NEW MEXICO
ENVIRONMENT DEPARTMENT

Hazardous Waste Bureau

**RE: NOTICE OF DISAPPROVAL
RFI REPORT FOR THE MAIN POST POL
AST RELEASE SITE (SWMU 219)
WHITE SANDS MISSILE RANGE, NEW MEXICO
EPA ID # NM 2750211235
HWB-WSMR-10-003**

FIGURE
1

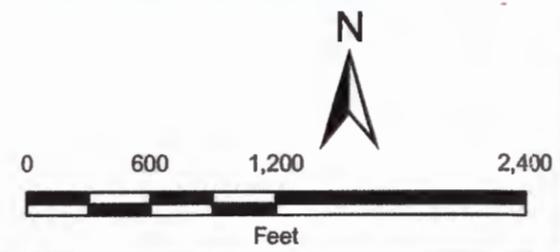
- a. Figure 1 (*Main Post Site Map*) must include the newly illustrated boundary of SWMU 219 provided by NMED and properly label the site “SWMU 219” in relation to the Main Post. The aerial photograph used to illustrate the Main Post must also be a current photograph. This figure must also include any other AOCs and SWMUs located in the vicinity of the Main Post POL. The title of Figure 1 must be changed to “White Sands Missile Range, New Mexico, Main Post POL SWMU 219.”

Printed from Google Map 01/02/11

SWMU 219 Boundary
